CLASS I SERVICE INSTRUCTIONS

No. 1220
ATA Code 71-00

SUBJECT: POWER PLANT - MODIFICATION OF THE CRANKCASE BREATHER TUBE

Figure 1.

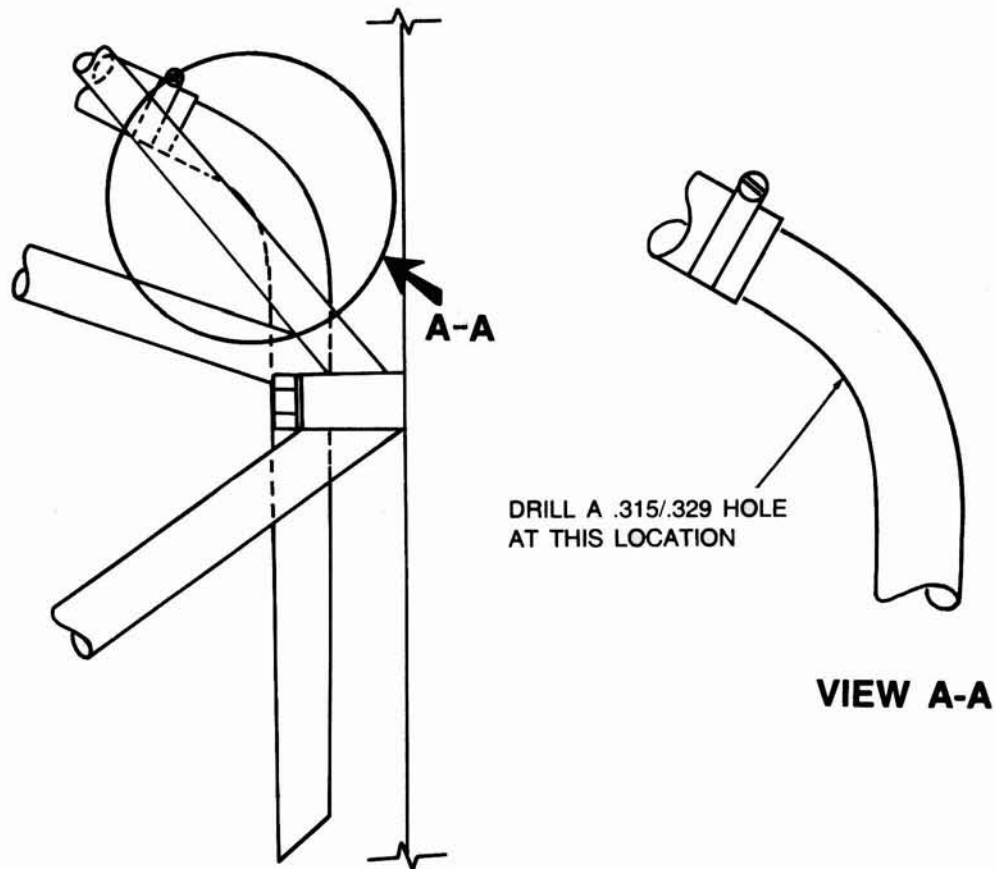
1. Remove the engine cowling.
2. Locate the breather tube and drill a .315/.329 inch diameter hole on the inside face and at the approximate

center of the tube bend (refer to figure 1).

Figure 2.

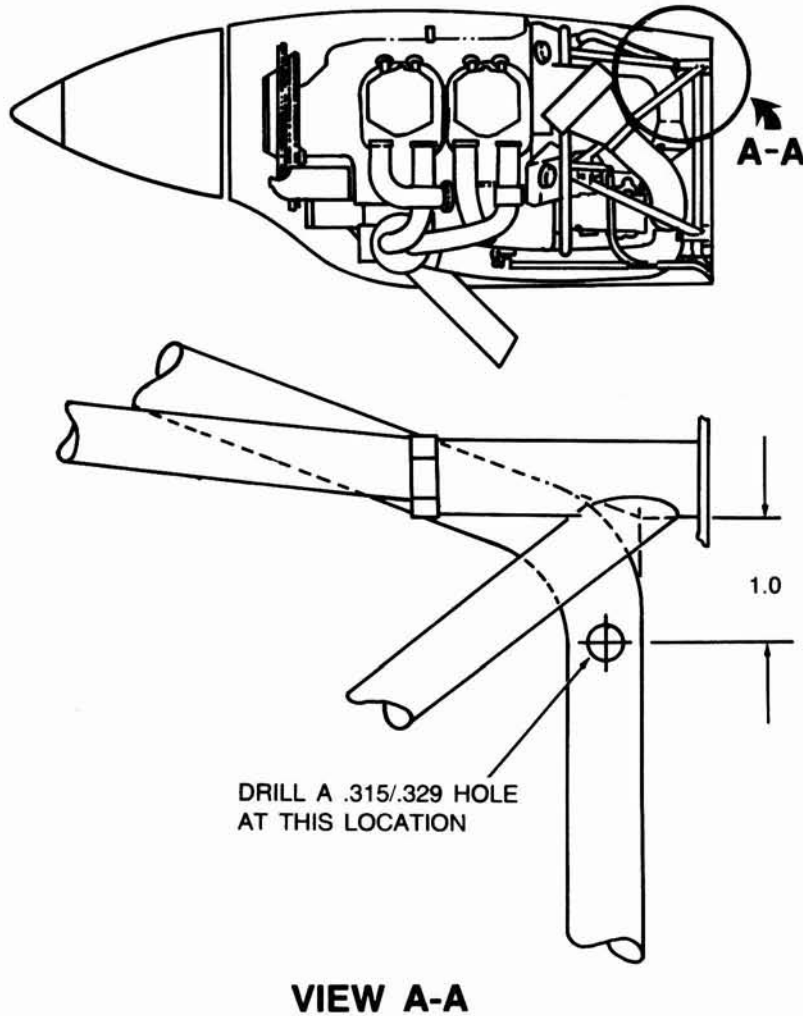
1. Remove the upper engine cowling.
2. Locate the breather tube and drill a .315/.329 inch diameter hole on the left side of the tube 1.0 inch below the engine mount-to-firewall attach lug (refer to figure 2).
3. Deburr the hole and reinstall the engine cowling.
4. Repeat the procedure on the other engine.
